CITY OF PROVIDENCE, RHODE ISLAND

RFP Title: Red Panda Exhibit

Addendum #: 3

Subject: Red Panda Exhibit - Projects Reply to Questions and Answers

EXTERIOR ENCLOSER EXHIBIT PLAN AND ELEVATIONS

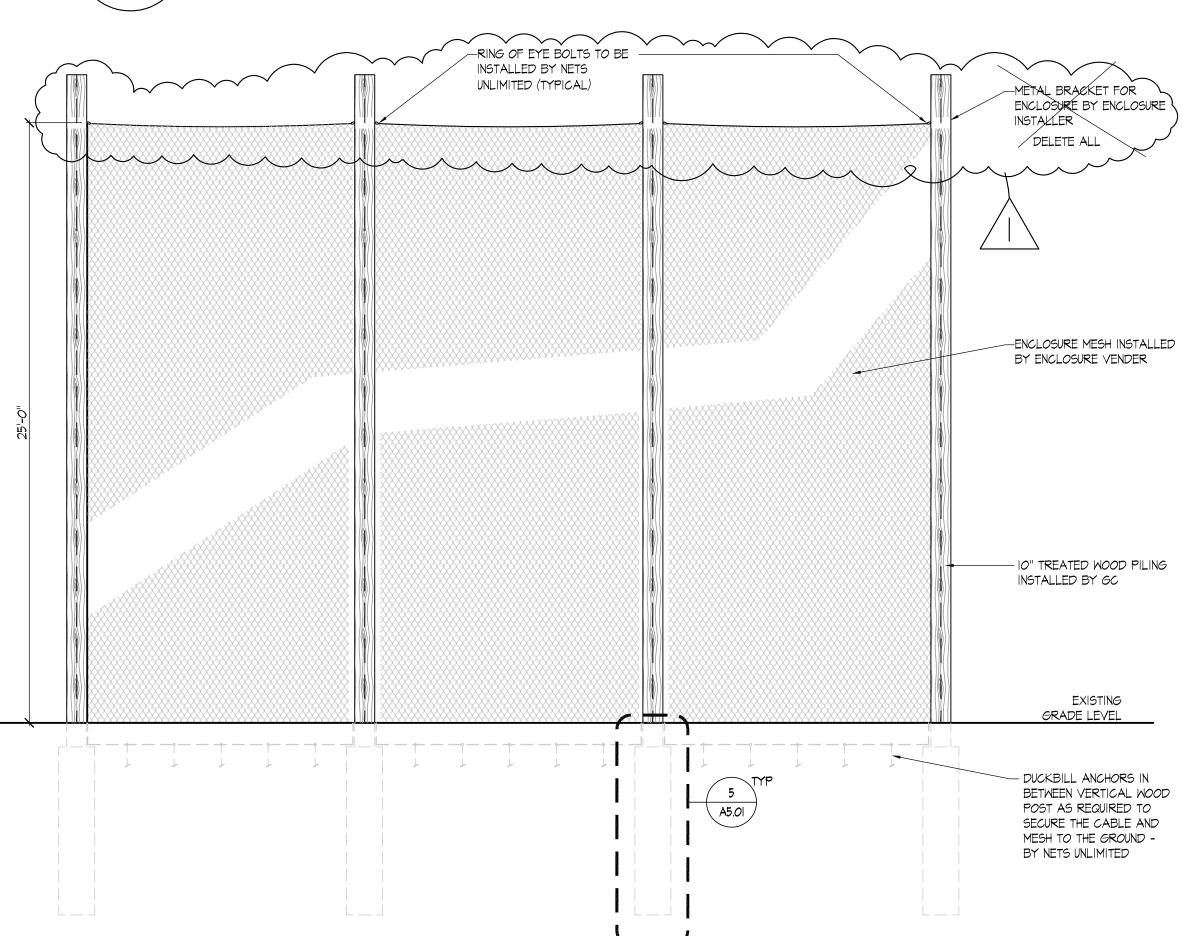
- 1. Contractor Question during Pre-bid meeting on February 14, 2023 asked who is responsible for metal collar at the top of the vertical post at exterior enclosure?
 - **A**. Answer was provided in memorandum and drawing A5.01 was updated to reflect correct reply.

<u>Question –</u> When we contacted Nets Unlimited, the drawing A5.01 defining the exterior enclosure noted that the metal collars located at the top of the vertical post were to be provided by Nets unlimited – they stated the metal collars are not in their scope of deliverables – Does the General Contractor need to provide these collars – Please advise?

<u>Answer:</u> Project team participated in a zoom call with Nets Unlimited on 2/16/2023 – the collars were discussed. Nets Unlimited has agreed to omit the collars and provide a series of eye bolts along the vertical inseam of the post to overlap and conceal the seam of the vertical mesh and provide a circle of eye bolts at the top of the post to be used for the roof canopy and vertical mesh to create the enclosure.

See revised drawing A5.01 attached and labelled Addendum #03

NETS UNLIMITED TO INSTALL NETS UNLIMITED TO INSTALL REQUIRED EYE-BOLTS AT REQUIRED EYE-BOLTS RING CENTER LINE OF INSIDE AT TOP LINE OF CANOPY EDGE VERTICAL POST TO AND VERTICAL MESH TO LINK MESH/ OVERLAP SEAM MAINTAIN ENCLOSURE FOR IMPROVED SECURITY -EXISTING MALKMAY DECK VERTICAL SUPPORT
 POST (SEE DETAILS) PROJECT REVIEWED WITH NETS UNLIMITED DURING A ZOOM CALL ON THURSDAY 2/16/23 SCOPE OF METAL BRACKETS WAS OMITTED AND NETS UNLIMITED HAVE ELECTED TO PROVIDE EYE-BOLTS - ENCLOSURE MESH AT VERTICAL POLES AND AS A RING DETAIL AT TOP OF POLE TO INSTALLED BY SUPPORT MESH WALLS AND ROOF ENCLOSURE VENDER - IO" TREATED WOOD PILING INSTALLED BY GC BUILDING PROPOSED EXISTING BUILDING GRADE LEVEL GC TO COORDINATE WITH -EXTERIOR EXHIBIT ENCLOSURE — DUCKBILL ANCHORS IN INSTALLER AND FABRICATOR BETWEEN VERTICAL WOOD SECTION OF ENCLOSURE ON NEW A5.01 POST AS REQUIRED TO BUILDING PROJECT SECURE THE CABLE AND MESH TO THE GROUND -BY NETS UNLIMITED
